**YARRA CITY COUNCIL**  
**Internal Development Approvals Committee**  
**Agenda**

**to be held on Wednesday 16 May 2018 at 6.30pm  
in Meeting Rooms 1 & 2 at the Richmond Town Hall**

**1.1 PLN17/0857 - 19 Howard Street, Richmond - Development of the land for a four-storey (plus rooftop terrace) office building (no permit required for use) and an associated reduction in the car parking requirements.**

1. This report provides an assessment of planning permit application PLN17/0857 for 19 Howard Street, Richmond and recommends approval subject to conditions.

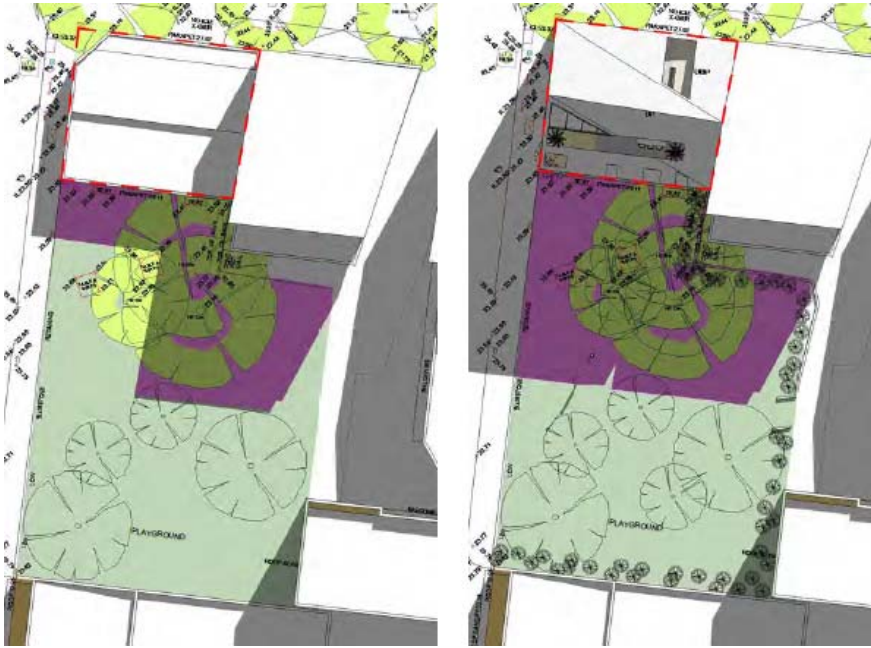
- (c) at 10.30am, the proposal will result in an additional 70sqm in shadowing in the western section of the park. Approximately 50 percent of the southern portion of the park will remain free of shadow. The image below depicts the difference (image on the left is existing, image on the right is proposed):

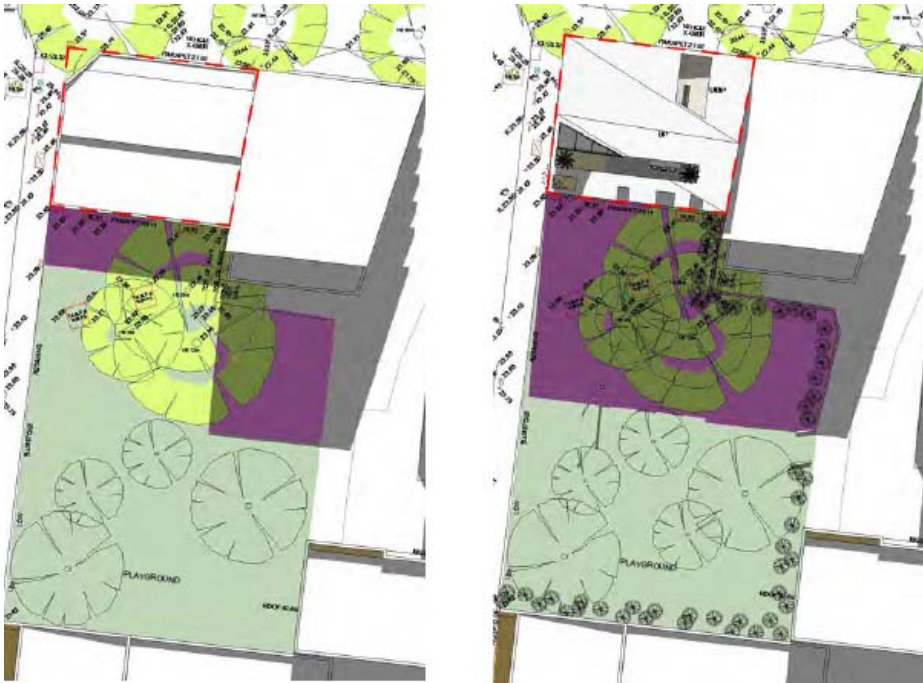
- (d) At 11am, the proposal will result in an additional 130sqm in shadowing in the western section of the park. Approximately 50 percent of the park will remain free of shadow. The image below depicts the difference (image on the left is existing, image on the right is proposed):

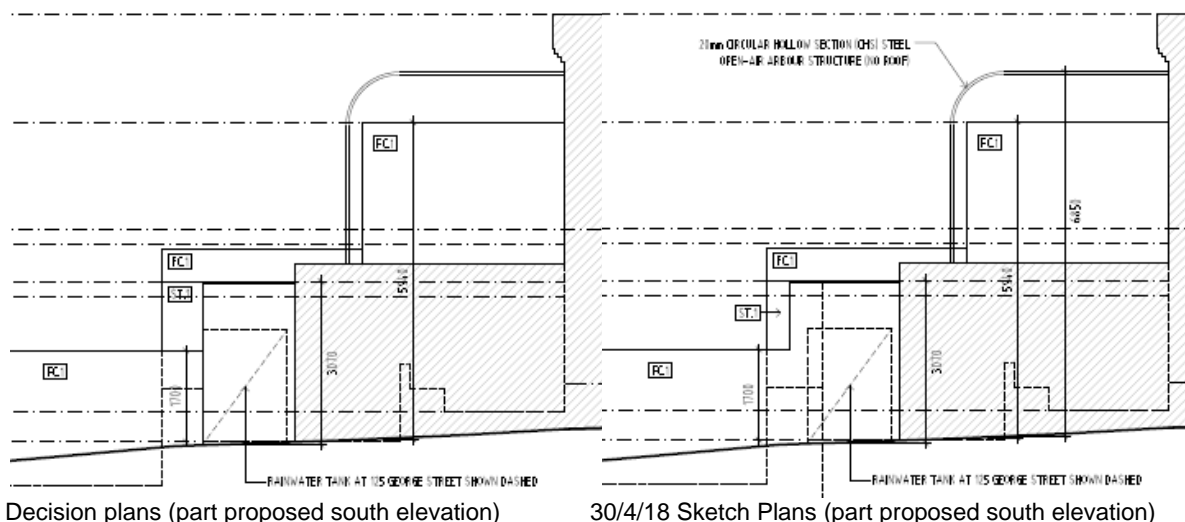
75. As the above table illustrates, the variations sought from Standard A10 relate to setbacks from the northern boundary to ground and first floor structures.

77. Further in relation to amenity impacts, the proposed non-compliant north-facing structures are all located opposite an approximately 1m wide walkway to the north-adjoining dwelling and opposite two south-facing windows and a full height, fixed obscured glazed window (depicted as a “door” on the plans) - all to habitable rooms. The wall also partially abuts (for a length of approximately 1.2m) rear secluded private open space (the rear courtyard) of the north-adjoining dwelling.

Proposed Shadow Diagrams (solid grey depicts shadows cast by proposed development to SPOS)

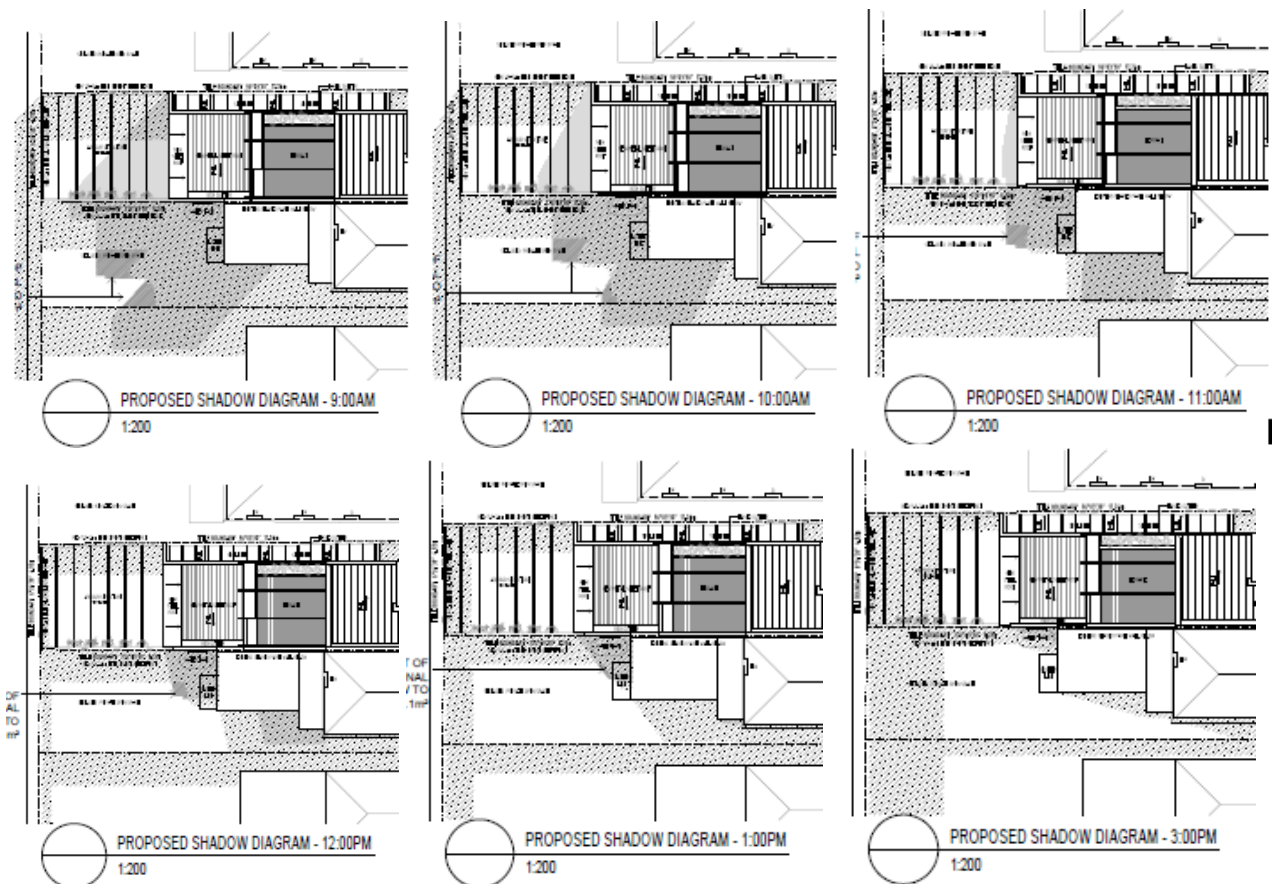
- 110. The proposal results in some additional shadowing onto the secluded private open space of No. 125 George Street which is approximately 48.4 sqm in area refer to image below).
- 111. Overshadowing must be assessed at the September Equinox, between the hours of 9am to 3pm. The proposed development casts additional shadows to the south-adjointing SPOS between the hours of 9am and 1pm. The table below provides a more detailed analysis of overshadowing to No. 125 George Street (as derived from shadow diagrams submitted with the application) and the images below the table represent the three hours of greatest overshadowing - between 9am and 11am. It is noted that no 2pm shadow diagram was provided, however officer analysis confirms that no additional overshadowing would occur by this time.

112. As the above table and images demonstrate, under existing conditions, the SPOS to No. 125 George Street does not receive solar access in accordance with the Standard (i.e. solar access to 75% of SPOS for at least three hours between 9am - 3pm at the September Equinox). Therefore, the additional overshadowing caused by the proposed development does not meet the Standard.
